STATE OF CONNECTICUT
CONNECTICUT SITING COUNCIL

IN RE: :
 :
APPLICATION OF CELLCO PARTNERSHIP : DOCKET NO. 413
D/B/A VERIZON WIRELESS FOR A :
CERTIFICATE OF ENVIRONMENTAL :
COMPATIBILITY AND PUBLIC NEED FOR :
THE CONSTRUCTION, MAINTENANCE :
AND OPERATION OF A WIRELESS :
TELECOMMUNICATIONS FACILITY AT :
723 LEETES ISLAND ROAD, BRANFORD, :
CONNECTICUT : FEBRUARY 24, 2011

RESPONSES OF CELLCO PARTNERSHIP d/b/a VERIZON WIRELESS TO
CONNECTICUT SITING COUNCIL PRE-HEARING QUESTIONS, SET ONE

Docket No. 413
 Response to Connecticut Siting Council Interrogatory Question #3
 Verizon Wireless PCS Coverage At 80 Feet AGL
 Branford, Connecticut and Surrounding Area
 (*Map Scale is 1:30,000)

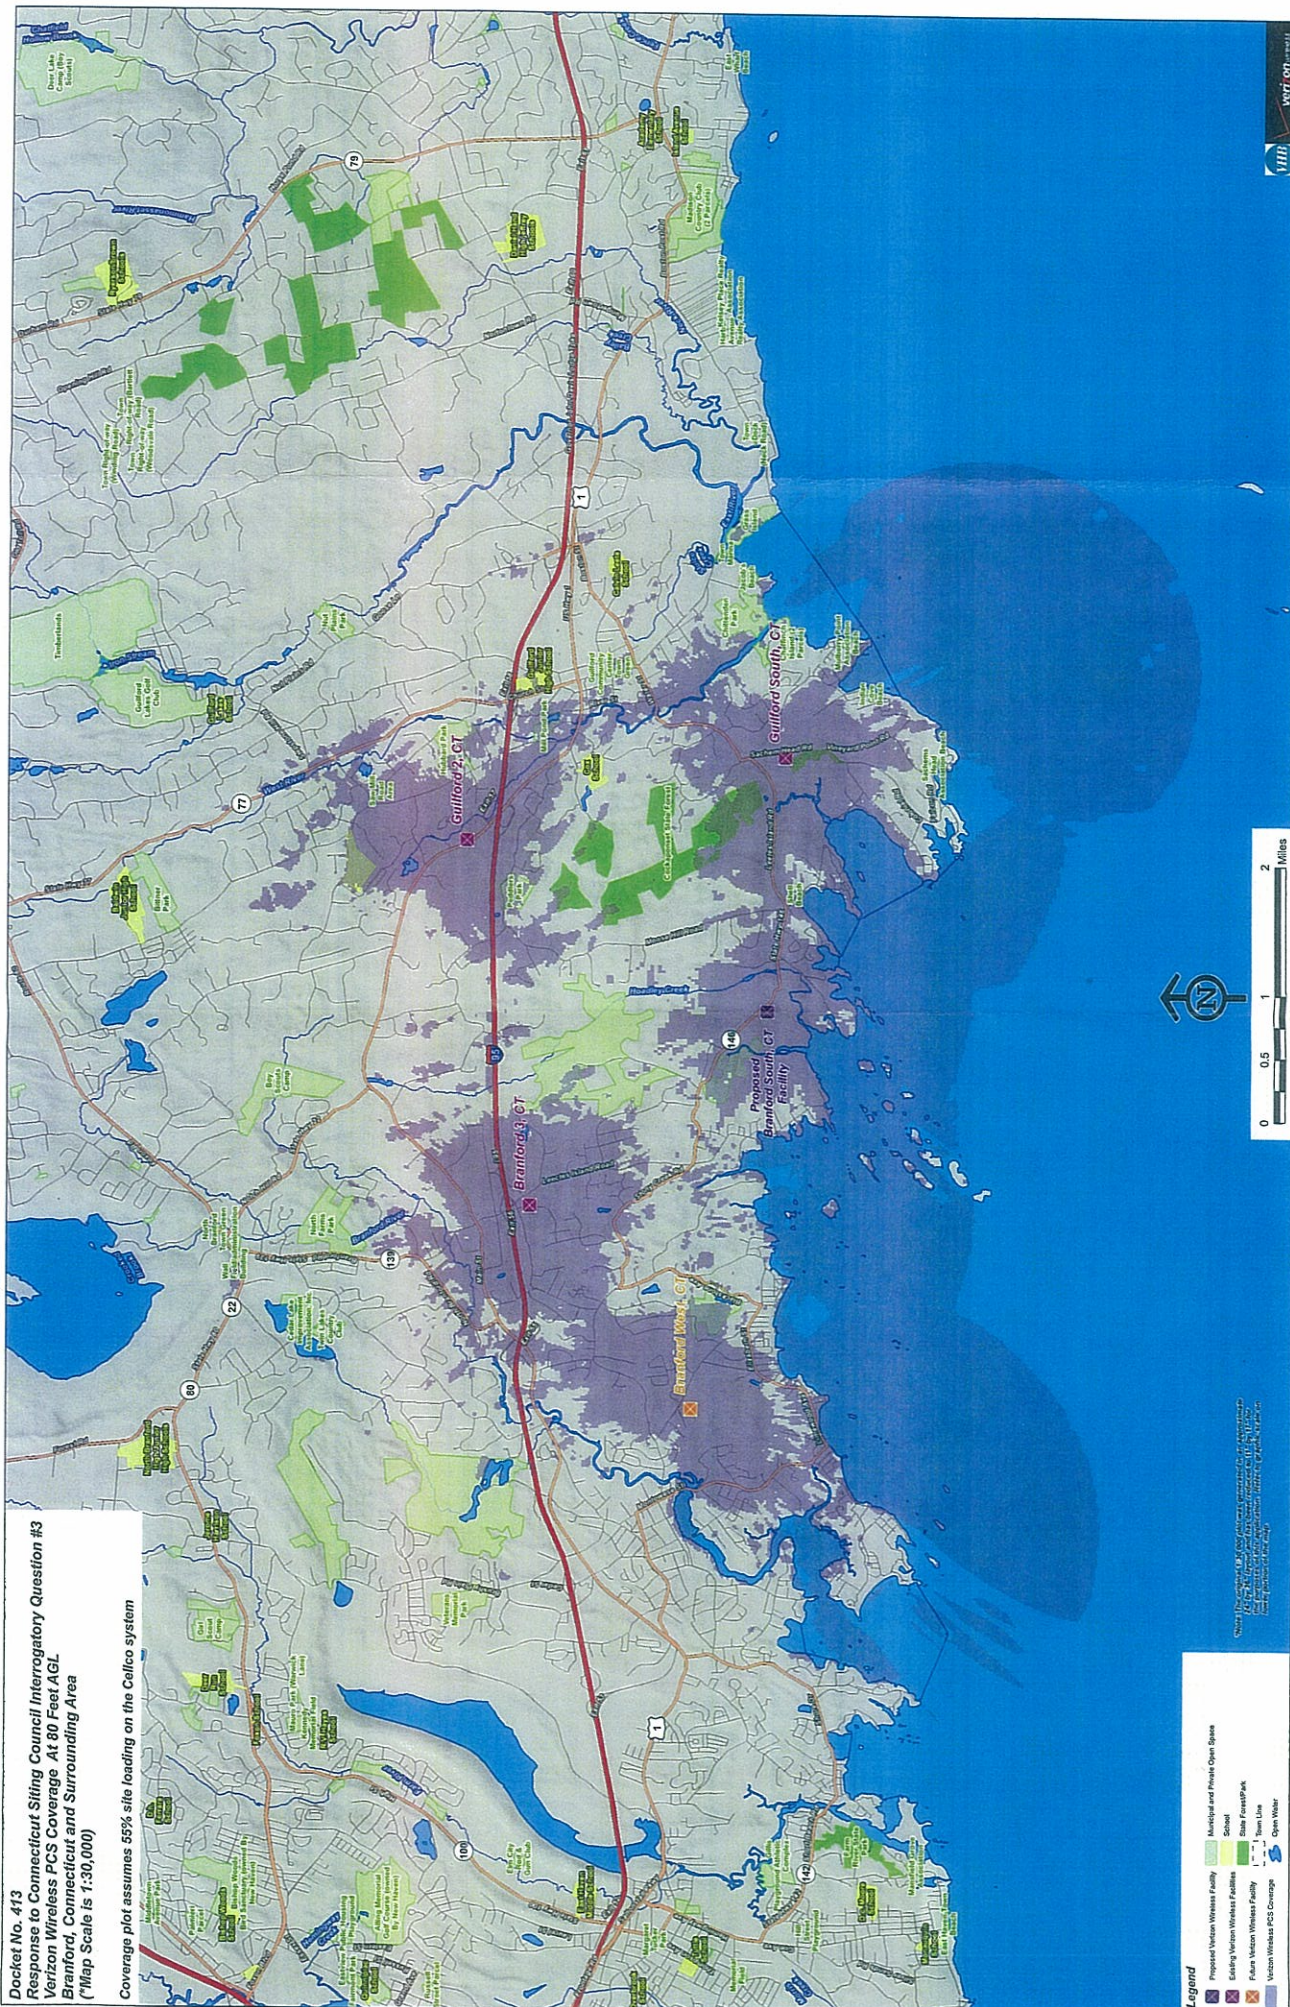
What is the lowest height at which Cellco's antennas could achieve its coverage objectives from this site? Submit propagation maps showing the coverage at ten feet below this height.

Cellco has determined that the 90-foot level is the minimum height needed to satisfy its Branford South coverage objectives. Plots showing Cellco's coverage at 80 feet from the proposed Branford South Facility are attached behind Tab 1. As illustrated on the plots, by reducing its antenna height to 80 feet, gaps in reliable service at both PCS and cellular frequencies begin to open up or widen along Route 146 to the west of the Branford South Facility. Likewise, existing coverage gaps at PCS frequencies to the east of the Branford South facility also begin to widen with Cellco's antennas at 80 feet.

The plots included behind Tab 1 of these responses assume an antenna height of 102 feet at Cellco's proposed Branford West cell site. At the time the Docket No. 413 application was filed, Cellco had reserved and anticipated installing antennas at the 92-foot level on this tower, below T-Mobile antennas at 122 feet, AT&T antennas at 112 feet and Pocket Communications antennas at 102 feet. Recently, Cellco learned that Pocket Communications would not be sharing the Pine Orchard Road tower making the 102-foot level available to Cellco. The additional 10
